Re: Legistar #85180

From: Kurt Stege <kurt.stege@gmail.com>
Sent: Sunday, October 6, 2024 11:21 PM
To: Madison Landmarks Commission; Latimer Burris, Amani; jmorrison@knothebruce.com; knkaliszewski@gmail.com; Taylorm@firstweber.com; rba@stonehousedevlopment.com; Bailey, Heather
Subject: 10.7.24 Landmarks Comm. meeting, Agenda Items 2, 3, 4
Attachments: Trinitas lot redivision size comparison.pdf; Southeast Elevation of Trinitas proposal with landmarks.jpeg

This email and attachments relate to the various proposals being advanced by Trinitas being considered by the Madison Landmarks Commission, Legistar File 84154, 85180, 85181.

For: October 7, 2024 Landmarks Commission meeting
 Agenda items 2, 3, 4

Trinitas lot redivision size comparison

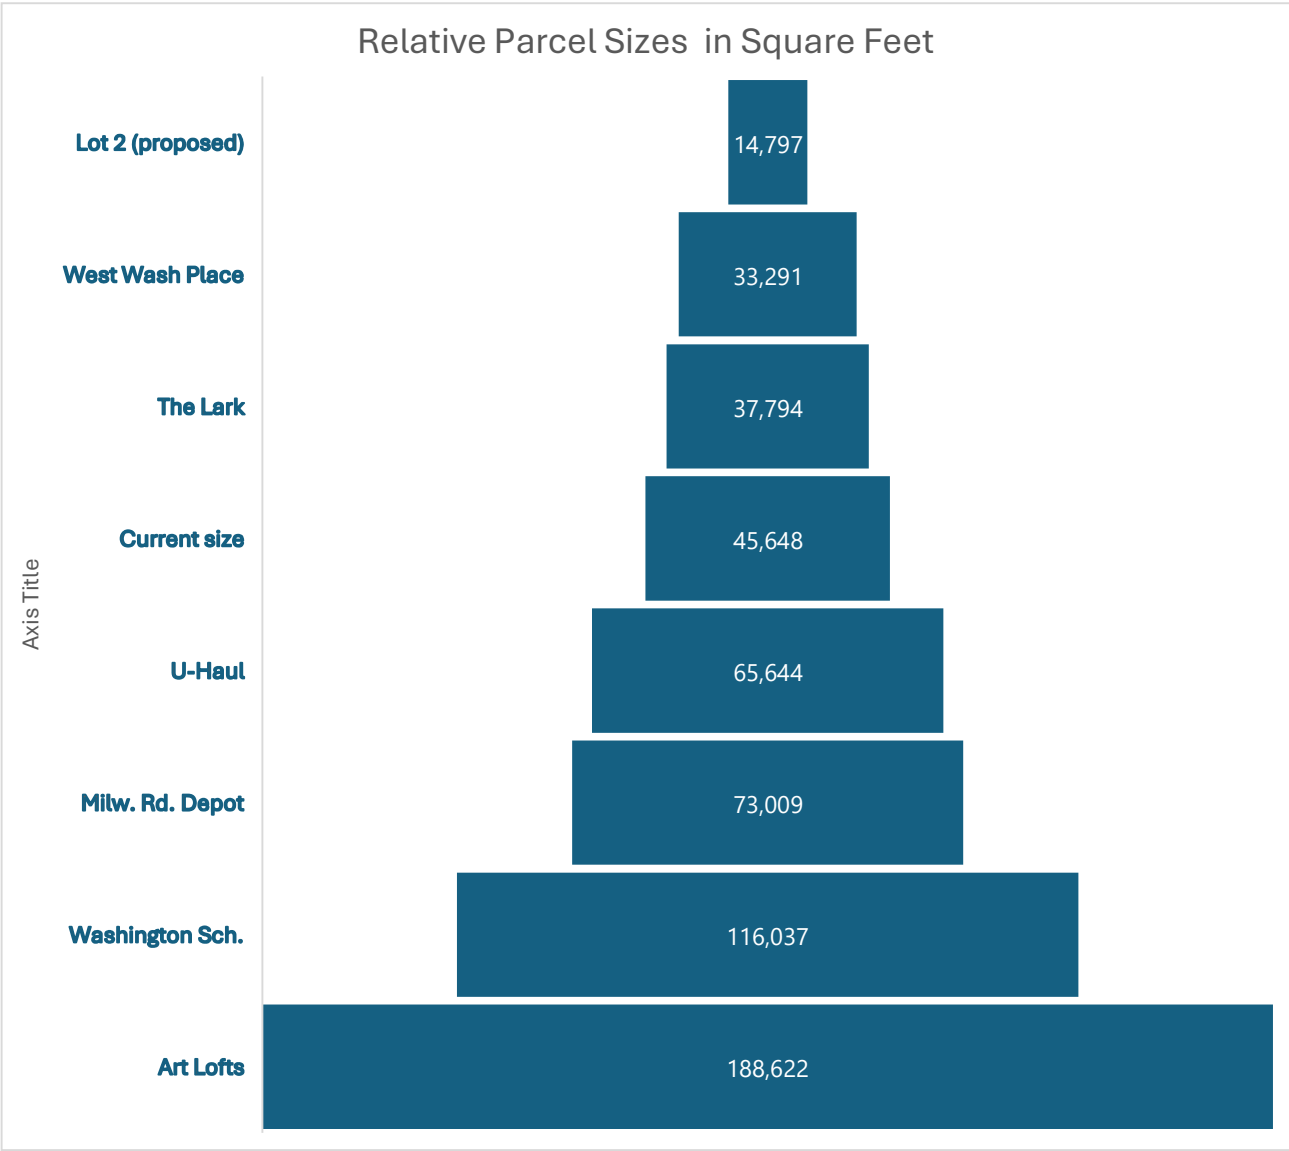
Proposal: Trinitas proposes that the parcel containing the Wiedenbeck & Dobelin Warehouse be reduced from 45,648 square feet to 14,797 square feet (Lot 2 of CSM).

Current lot of Wiedenbeck & Dobelin Warehouse, Parcel 070923229095: 45,648 square feet. Lot 2 would be **32%** of this size.

699 Station, Parcel 070923229285: 16,672 square feet. [Not a landmark, and **will no longer exist.**] Lot 2 would be 89% of this size.

Lot 1 (location of proposed new building): 47,540 square feet. Lot 2 would be **31%** of this size.

Southeast Elevation
 (to scale unless otherwise noted)

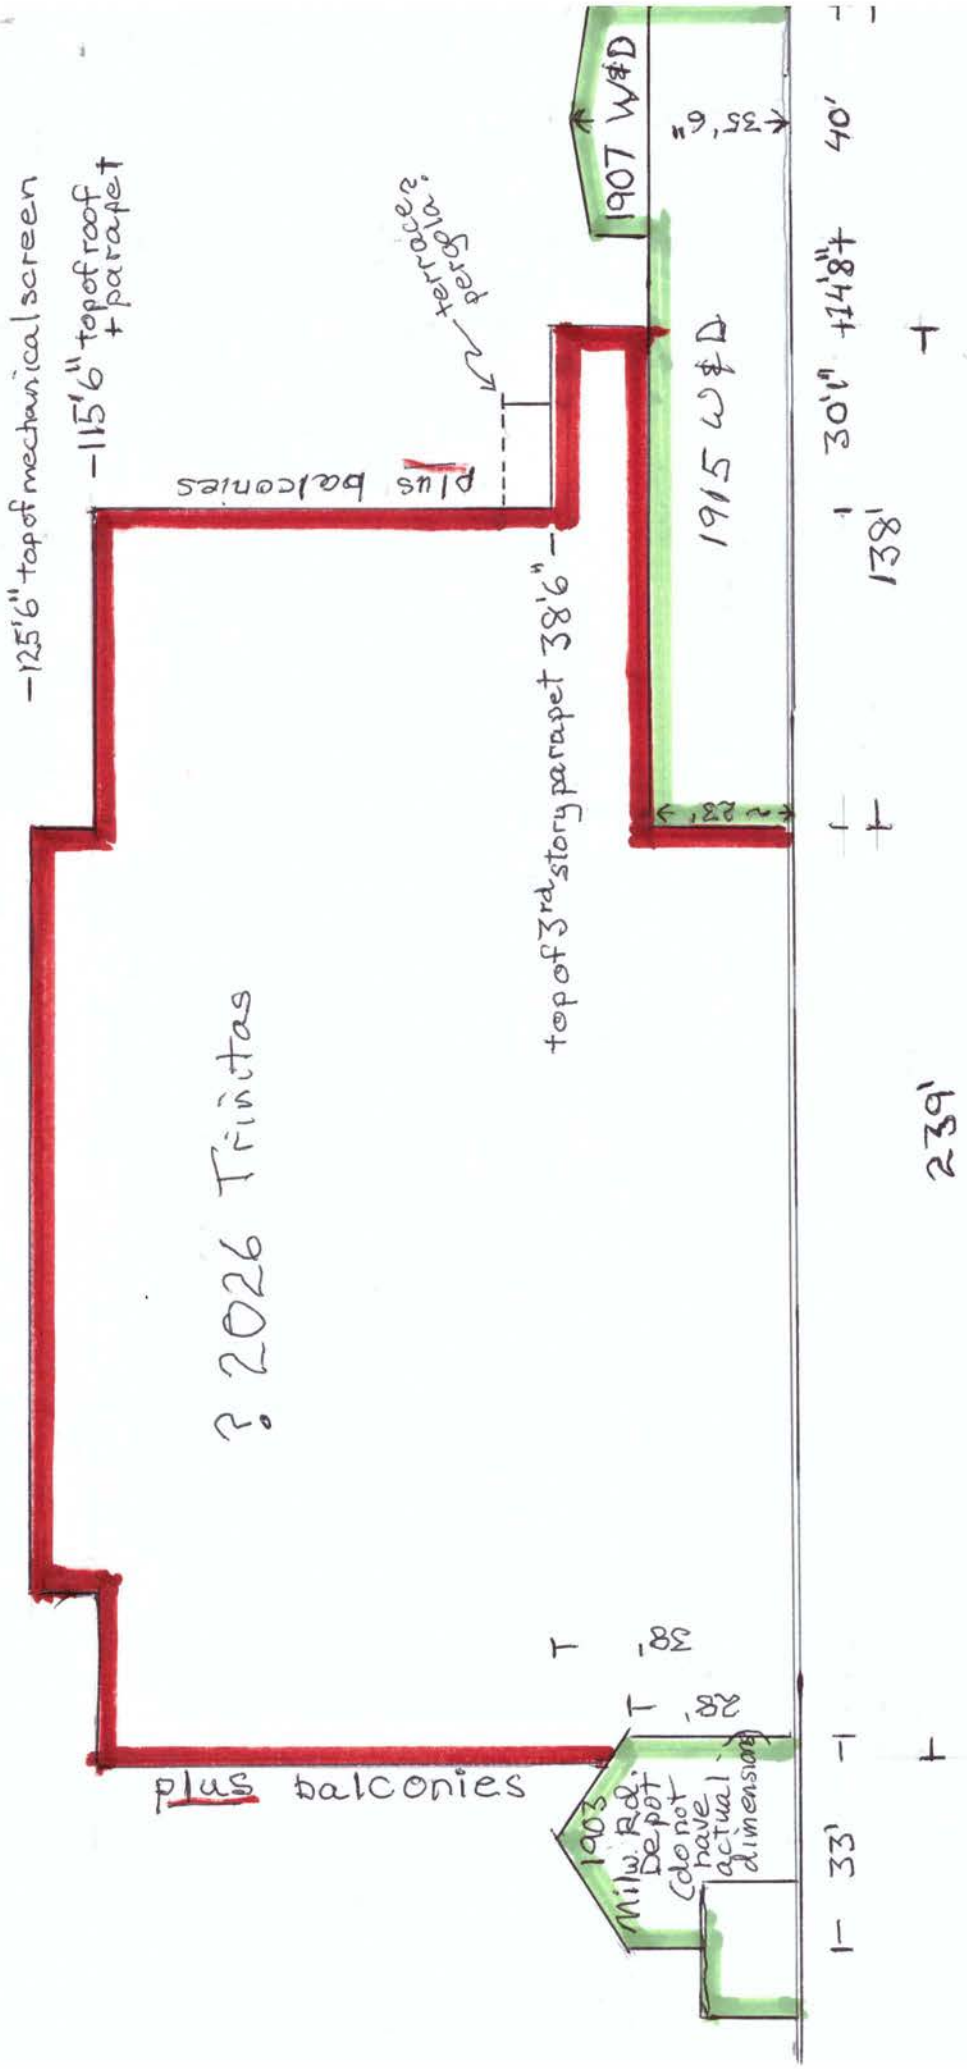
1. A "Trinitas Lot Redivision Size Comparison" which includes a chart on page 2.
2. A "Southeast Elevation" (to scale) comparing outlines of the southeast facades of three relevant buildings in their relative positions. Note that the 1903 Milwaukee Road Depot is set at an angle relative to the other two buildings, and that I did not have its measurements. The representation is an estimate from Google Map images.
